Tender Reference	SY_2026_OT_001_CIVIL WORKS
Date	5th August 2026

Subject: Clarifications to Requests for Invitation to bid for rehabilitation works of National Public Hospital of Al-Rastan, Homs Governorate

Abstract on Dwg ARH-A.003

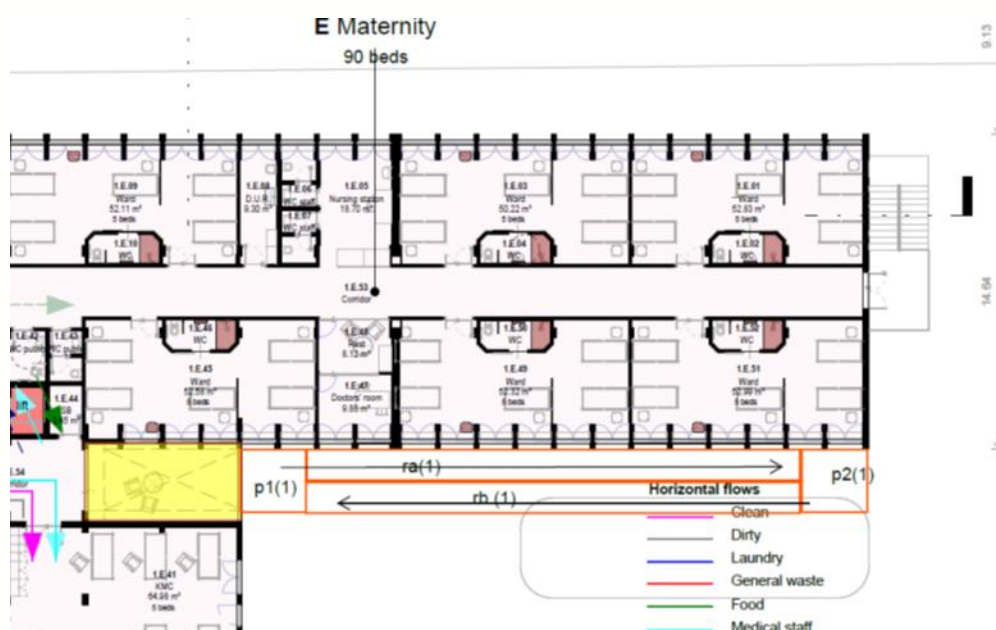
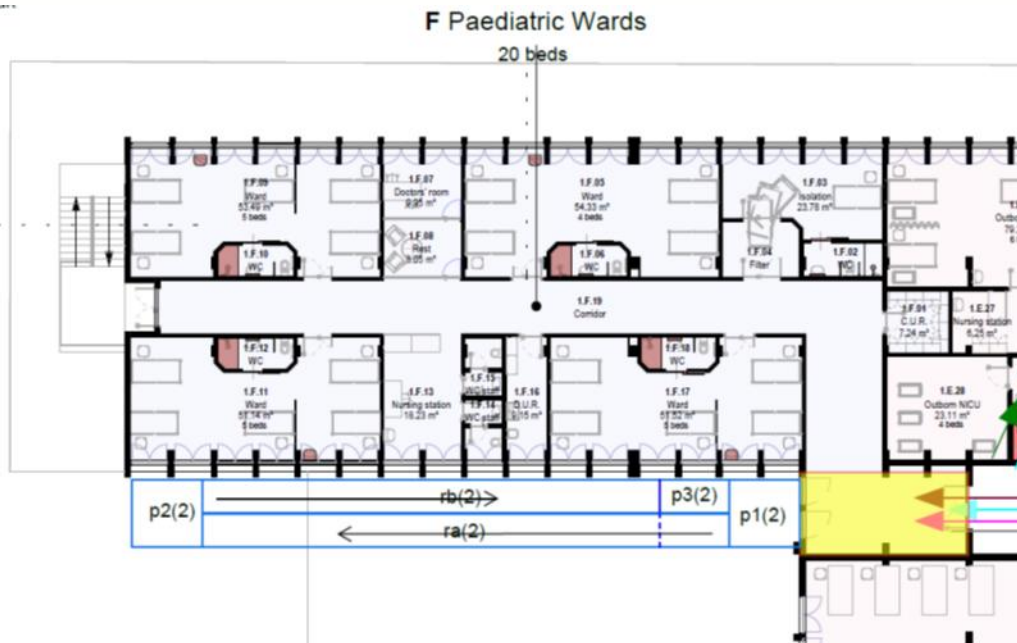
The Bidder has requested clarification regarding the steel ramps under Item 12.1.1 – Metal Ramp, noting that the technical specifications do not provide location, measurements, specifications, or details.

Three ramps are planned, distributed as follows:

Ramp	Location	Starting Level	Arrival Level	Slope	Total Length
R1	East side	+3.70 m (L1)	0.00 m (ground floor)	8%	46.30 m
R2	East side	+3.70 m (L1)	-1.10 m (terrace)	7.5%	64.00 m
R3	West side	-1.10 m (terrace)	-5.47 m (L-1)	7.5%	58.20 m

R1 - 8% Slope			
Description	Item	length (m)	Level (m – with respect to +0.00)
platform	p1(1)	3.00	3.70
Sloped ramp	ra(1)	23.15	1.85
platform	p2(1)	3.00	1.85
Sloped ramp	rb(1)	23.15	0.00
